Perry Buckberg - Re: Safety Evaluation Review Team - Exit Meeting - Plymouth h - 01.30.07- request for information

Safety Evaluation Review Team - Exit Meeting -Plymouth - 01.30.07

1. Buried Pipes

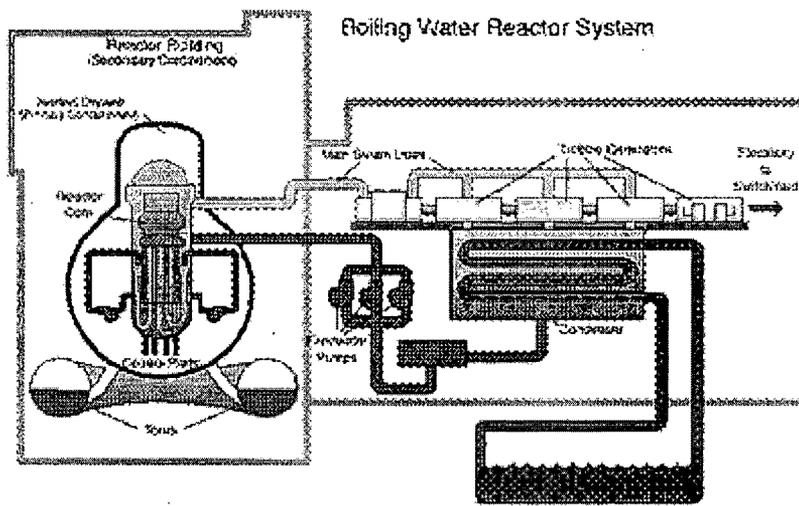
At the Exit meeting, NRC stated that there was water in the Torus. We note water in the Torus has been identified before.

Q.2.C. Corrosion of Torus shell: Example, during RFO14 (April 2003) ultrasonic thickness examination of the Torus shell, several measurements were below the nominal wall thickness of 0.629." The applicant stated that since the measurements were all greater than the minimum allowable thickness of 0.563", no further action was taken; and identification of degradation and corrective action prior to loss of intended function provide evidence that the program is effective for managing aging effects.

This is Orwellian reasoning what it indicates simply is that there is corrosion. Will there be testing before 2012, schedule and method? What testing of the Torus shell is planned for 2012-2032, schedule and method?

Q.2.D. We recollect that it was opined that the water in the Torus came from groundwater; is that correct?

- 1) If the water is thought to have come from groundwater, how did it get there - from rain/moisture seeping down through the ground; from the water table, water coming up; from the ocean; a combination?

- 2) What is the height of the water table; what is the distance from the water table to a specified location on the building; indicate on diagram provided at Exit Meeting?

- 3) Was the water in the Torus tested for salinity - especially important considering the corrosive effect of salt on concrete? If so, what was the result?

- 4) Was the water tested for radionuclides? If so, what was the result?
- 5) If the water got in, we can assume it can get out. Is this correct? If correct, where would it go; what tests are performed on said water for its radiological and chemical content?

- 6) Is the Torus checked for water now and what will be required from 2012-2032? If required, what is the schedule and method used to check for water now and during 2012-2032?

- 7) Will monitoring wells be required to test for leakage into the ground?
- 8) If water is in the Torus what assurance is there that the water will not eat into, weaken, the adjacent concrete that supports the dry well? There is no indication that they have made UT inspections at the lower, middle and embedded regions -how do we know whether there is corrosion?
